**SPECIALIST COMMENTS RESPONSE – 88,130,133 UPPER OREWA ROAD AND 53A,53B,55 RUSSELL ROAD, OREWA**

Further to your recent instructions, we have reviewed comments received on 26 June 2025 and have responded to the transport matters raised.

**1 AUCKLAND TRANSPORT – TESSA CRAIG**

Revision notes:			Drawn by: HA J003135	Project: Delmore, Orewa Proposed Residential Development	Date: 27/05/25		Figure:  SD 1
Rev:	Date:	Notes:

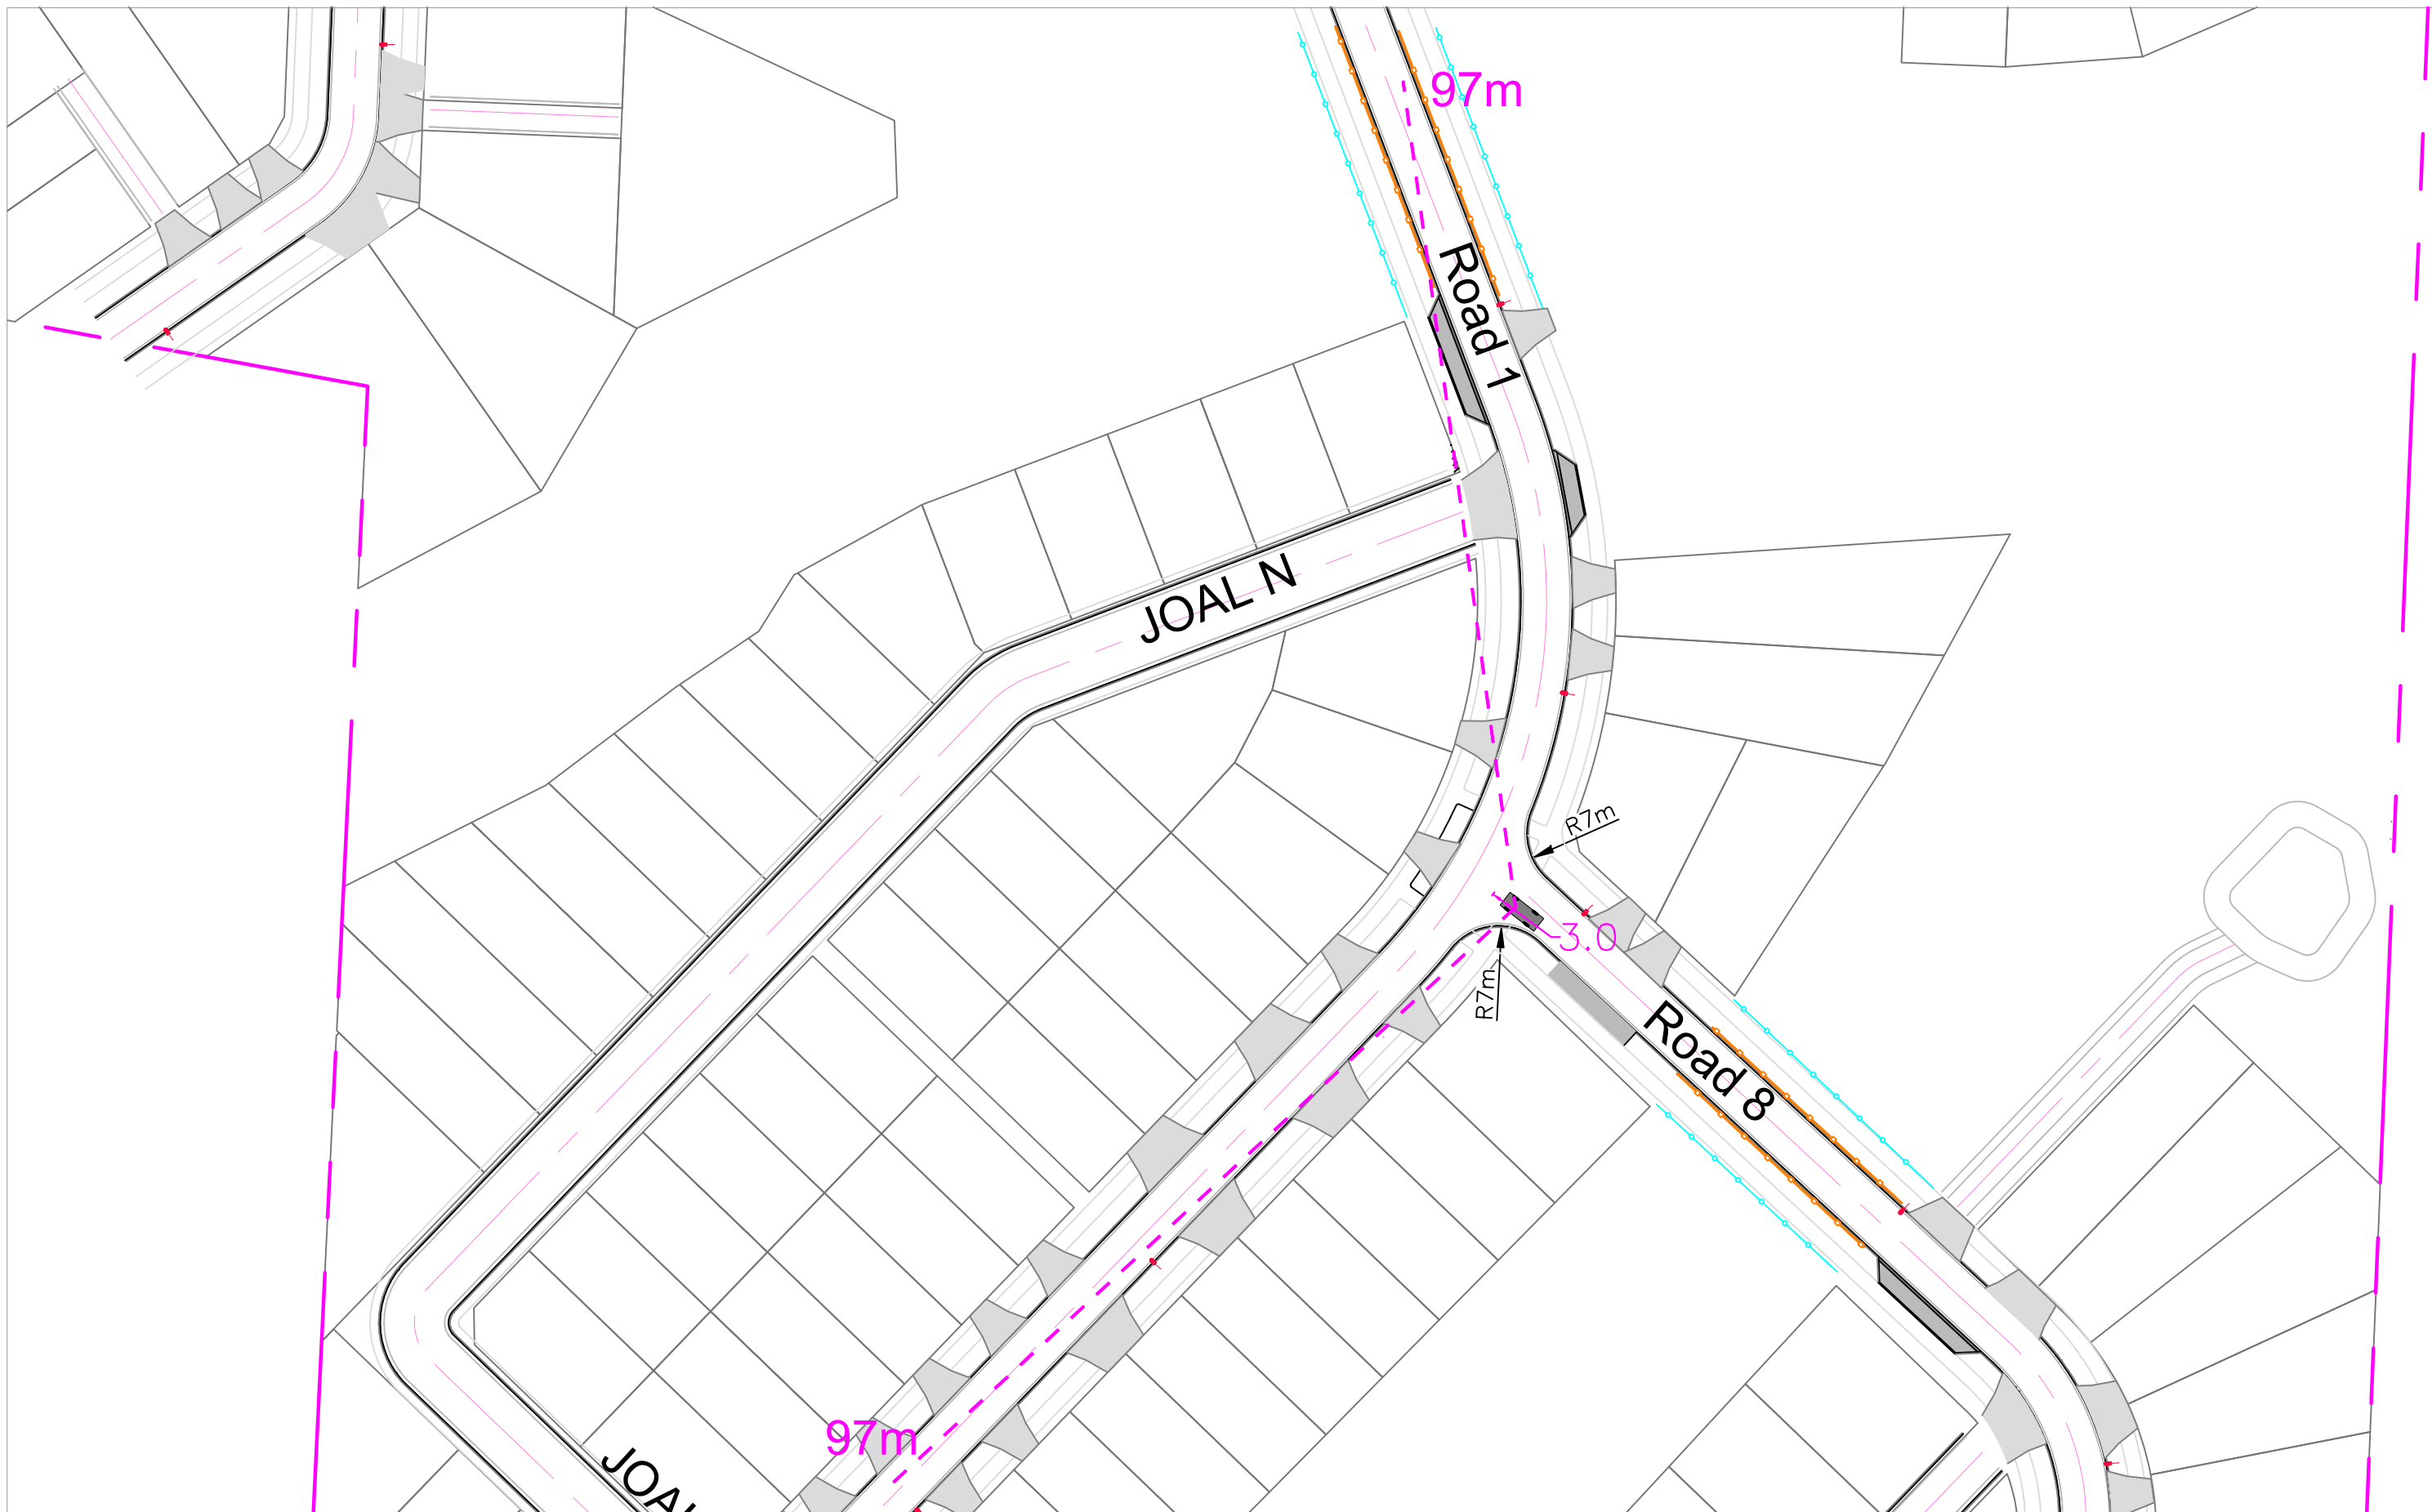
- Intersection F (Road 6 / Road 1). This is on Grand Dr and it is close to a horizontal curve. The updated assessment (refer Drawing SD 1 of the 12 June letter) shows that, in order to achieve recommended sight distances, there will need to be an area within private lots on the inside of the curve north of Road 6 which will have only low level planting and structures. I recommend a condition of consent is sought requiring a consent notice to be registered on the title of these lots.

- Intersection J (Road 8 / Road 1). 97m is achieved in both directions. It is noted that to the north the horizontal curve will likely reduce operating speed.
- Intersection F (Road 6 / NoR 6). 97m is achieved to the south. To the north, the sight distance is currently limited to 80m. To achieve 97m there needs to be a small sliver of low level planting as per drawing SD1. This will be included in the consent conditions.

Revision notes:			Drawn by: HA J003135	Project: Delmore, Orewa Proposed Residential Development	Date: 27/05/25		Figure:  SD 2
Rev:	Date:	Notes:					
			Client:	Drawing Title: Sight Distance Intersection J	Scale @ A3: 1:667

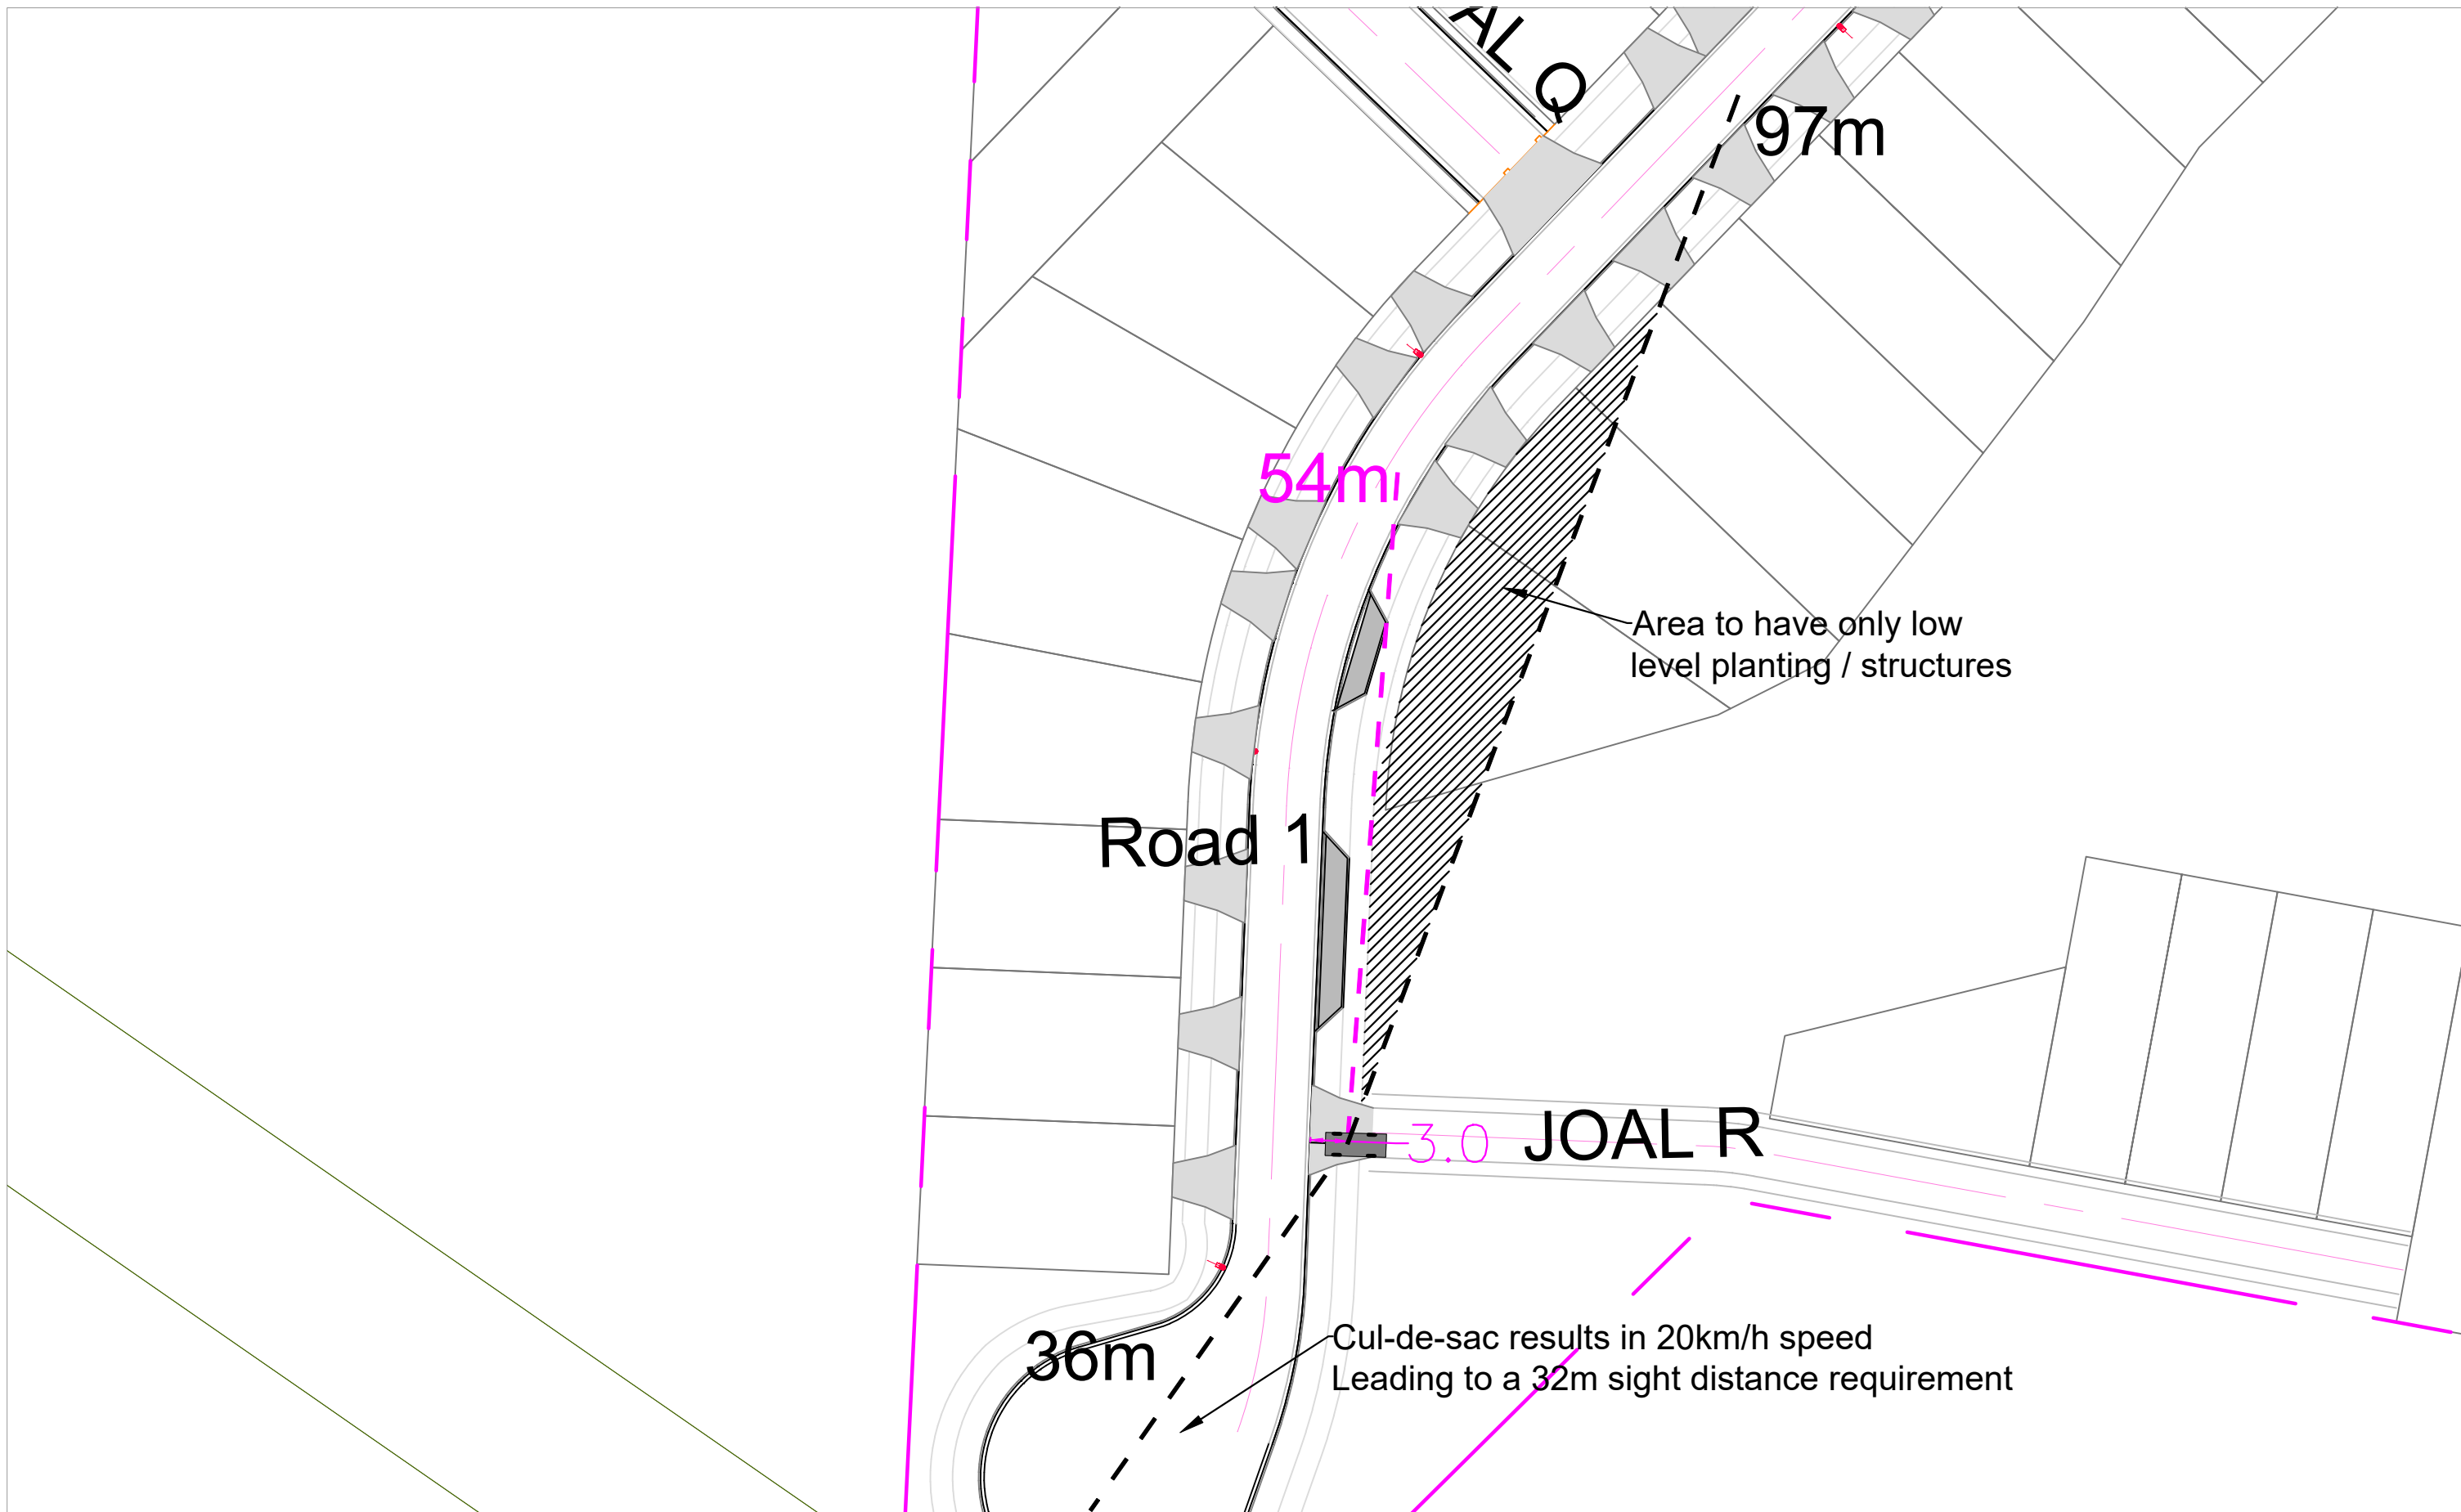
- Intersection J (Road 1 / Road 8). The updated assessment (refer Drawing SD 2 of the 12 June letter) shows sight lines cutting across the boundary of two lots north of Road 8. Unlike Drawing SD 1 this has not been annotated on the drawing. I recommend that a similar consent notice condition is imposed on these two lots.
